Consideration of Comments

Project Name:	2015-10 Single Points of Failure TPL-001-5
Comment Period Start Date:	2/23/2018
Comment Period End Date:	4/23/2018
Associated Ballot:	2015-10 Single Points of Failure TPL-001-5 AB 2 ST 2015-10 Single Points of Failure TPL-001-5 Implementation Plan IN 1 ST

Figure 5–12 — Station DC Supply and Monitoring

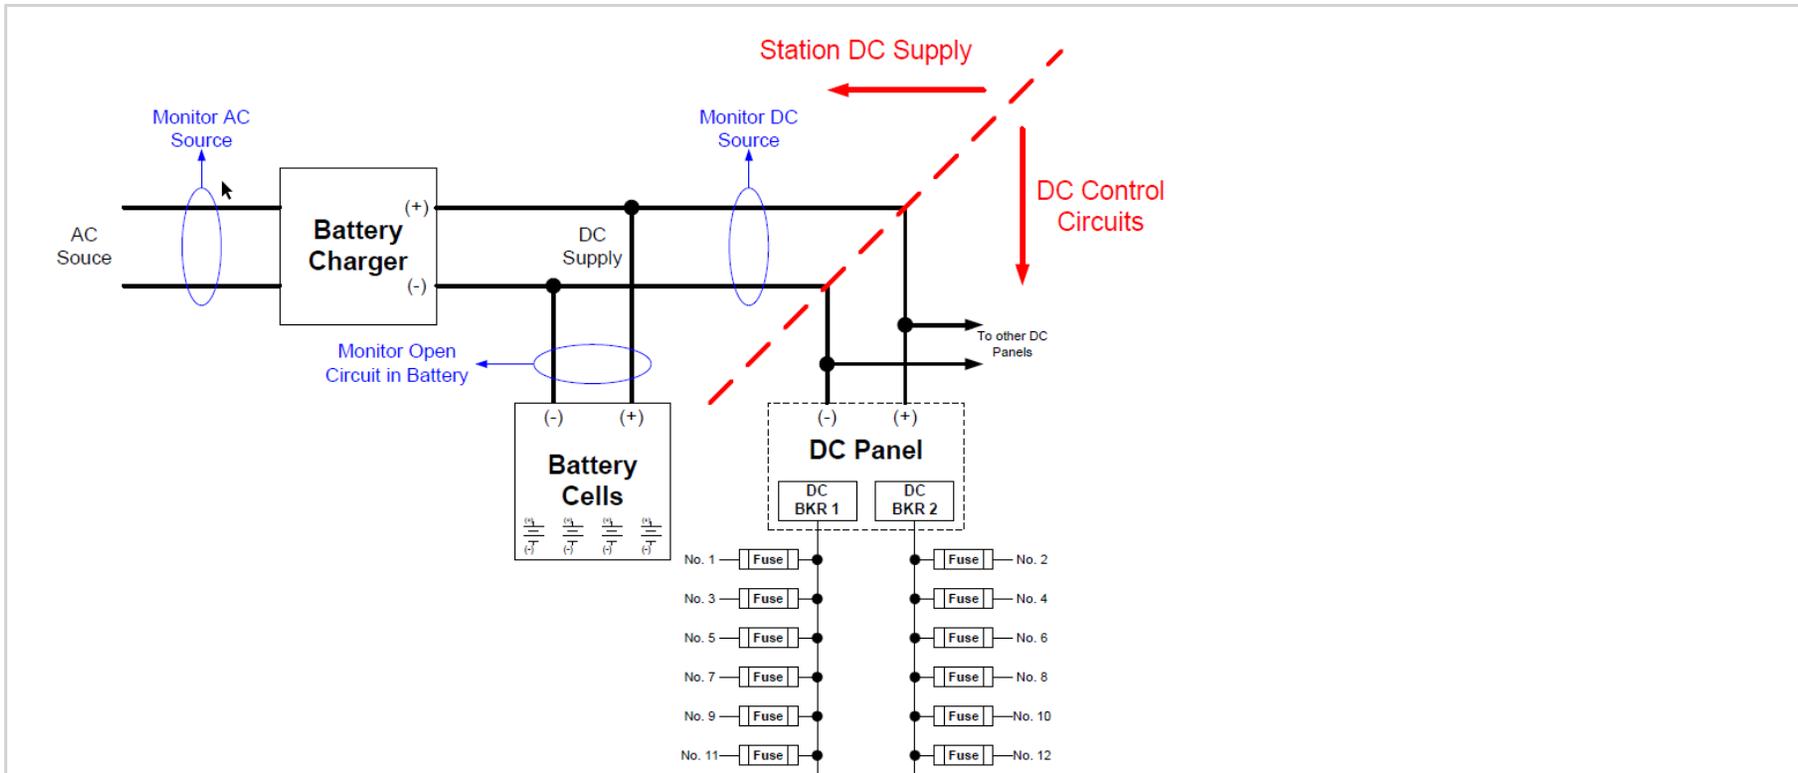
1. Changes were made to the language related to outages along with revisions to parts 2.1.3 and 2.4.3. The TP/PC needs to have a technical rationale that identifies which outages are “significant”.

2. The station DC supply includes station battery, battery chargers and non-battery-based dc supply. This list is included in the NERC Glossary of terms under “*Protection System*”. There is a NERC Technical Paper dated November 2008 titled “*Protection System Reliability Redundancy of Protection System Elements*” which explains why monitoring an “open circuit” is required. The SAMS and SPCS recommendation from Order 754 and Section 1600 data request aligns with most of the elements in the NERC Technical Paper. For reference Figure 5-12 is copied from this technical paper.

For these reasons monitoring of both open circuit and low voltage are required **OR** redundant meaning two batteries, and redundant meaning two battery chargers, etc. The SDT is sympathetic to the fact that open circuit may be problematic and could introduce additional points of failure. However, the FERC directive, SAMS and SPCS Order 754 recommendations and NERC Technical Paper needs to be followed.

Figure 5–12 — Station DC Supply and Monitoring

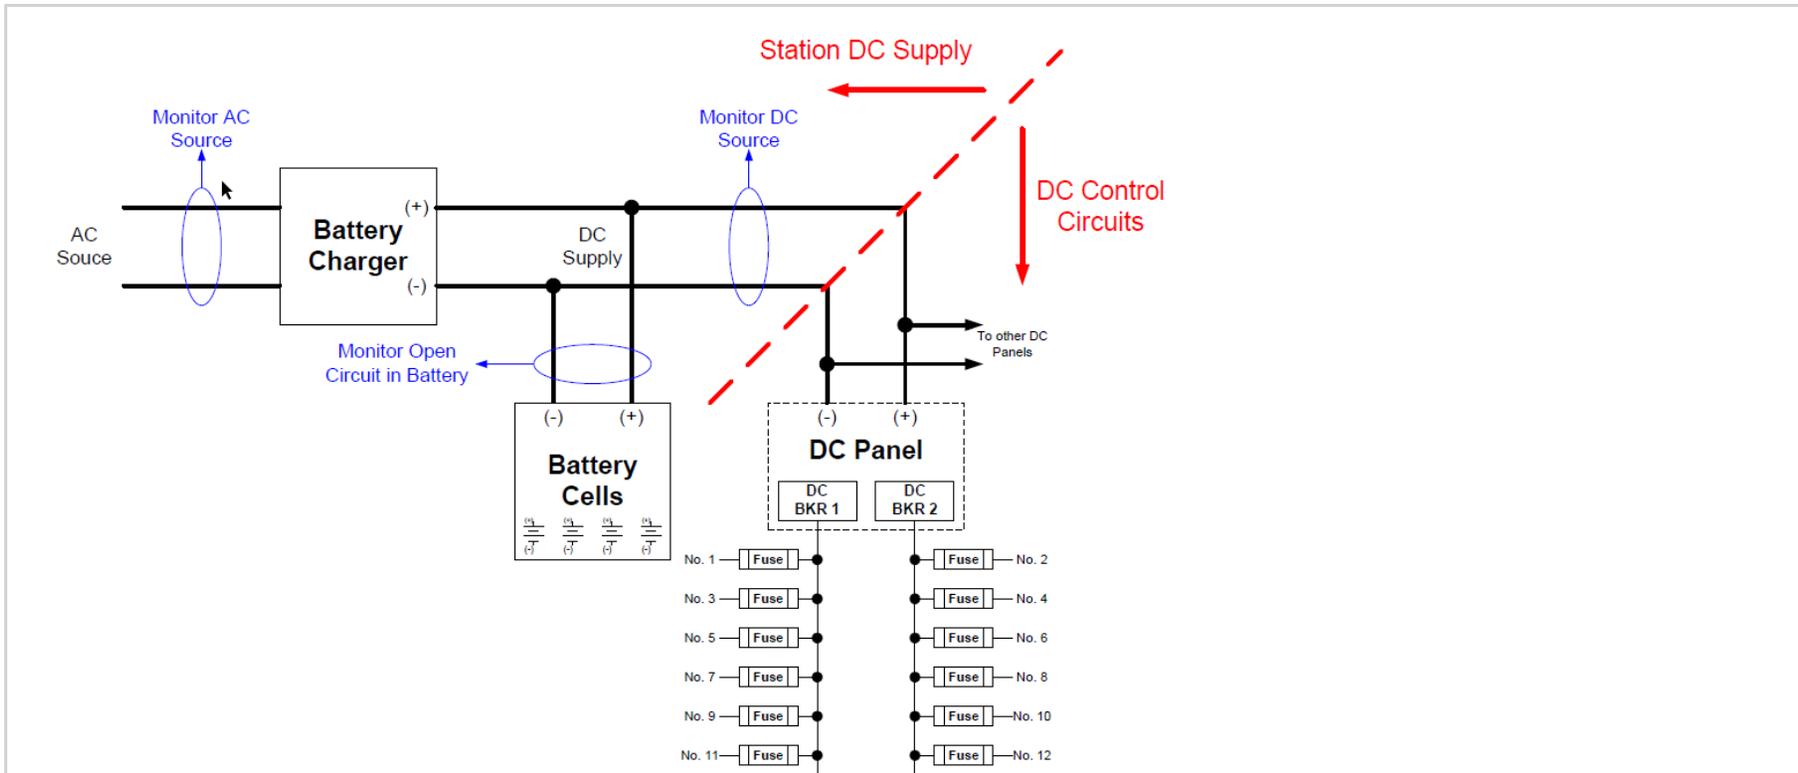
Document Name	
Comment	
<p>Hydro One still has concerns with the following points regarding Footnote 13:</p> <ol style="list-style-type: none"> 1) 13c – The term “open circuit” is not clear. Please provide clarification of the term and an example of how it is typically monitored in the supplementary material for better understanding. 2) 13d – We recommend that a single trip coil that is “monitored and reported at a Control Center” be treated the same way that communication systems (Footnote 13b) and DC Supply (Footnote 13c) are treated (to meet the redundancy requirement). 	
Likes	0
Dislikes	0

Response	
<p>1) There is a NERC Technical Paper dated November 2008 titled “<i>Protection System Reliability Redundancy of Protection System Elements</i>” which explains why monitoring an “open circuit” is required. The SAMS and SPCS recommendation from Order No. 754 and Section 1600 data request aligns with most of the elements in the NERC Technical Paper. For reference Figure 5-12 is copied from this technical paper.</p>

2) Monitoring was added to footnote 13d.
